# Access Compliance Report

## Public Rights-of-Way

Intersection ID: 3821	Main Street: BERSHIRE_LN	Cross Street: MARBLE_HILL_DR	Location: NW
ADA ID: BDE20092699F	Ramp Type: Perp	Initial Pass/Fail: Fail	Overall Compliance: No
Severity Score: 25			
Codes/Mitigation Info/Possible Solution		Field Measurements/Component Compliance

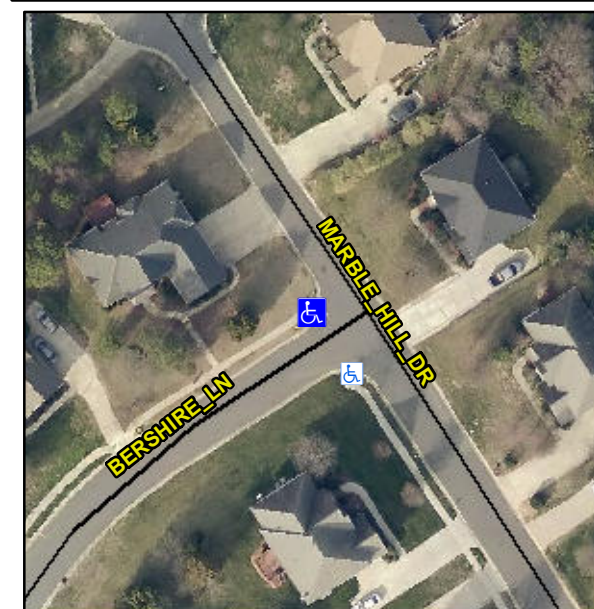
**Not Found, R304.5.3**

Compliance	Description	Data	Compliance	Description	Data
N/A	Ramp Length (in)	49.0	Yes	Ramp Slope (%)	5.6
Yes	Ramp Width (in)	69.0	No	Ramp XSlope (%)	11.1
N/A	Flare Type LT	N/A	N/A	Flare Type RT	N/A
N/A	Flare Slope LT (%)	N/A	N/A	Flare Slope RT (%)	N/A
N/A	Flare Traversable LT?	N/A	N/A	Flare Traversable RT?	N/A
N/A	Landing Length (in)	N/A	N/A	DWS Provided?	N/A
N/A	Landing Width (in)	N/A	N/A	DWS Contrast?	N/A
N/A	Landing Slope (%)	N/A	N/A	DWS Length (in)	N/A
N/A	Landing X Slope (%)	N/A	N/A	DWS Full Width?	N/A
N/A	Landing Curb? (Y/N)	N/A	N/A	DWS Offset (in)	N/A
N/A	Shared Landing?	N/A			
N/A	Gutter Ponding?	N/A	N/A	Gutter Slope (%)	N/A
N/A	Gutter Lip Ht (in)	N/A	N/A	Gutter X Slope (%)	N/A
N/A	Painted X Walk1?	No	N/A	Painted X Walk2?	N/A
	X Walk 1 Direction	To S		X Walk 2 Direction	N/A
N/A	X Walk 1 Width (in)	N/A	N/A	X Walk 2 Width (in)	N/A
	X Walk 1 Slope (%)	9.6		X Walk 2 Slope (%)	N/A
	X Walk 1 X Slope (%)	3.0		X Walk 2 X Slope (%)	N/A

**Remove & Replace Entire Ramp.**
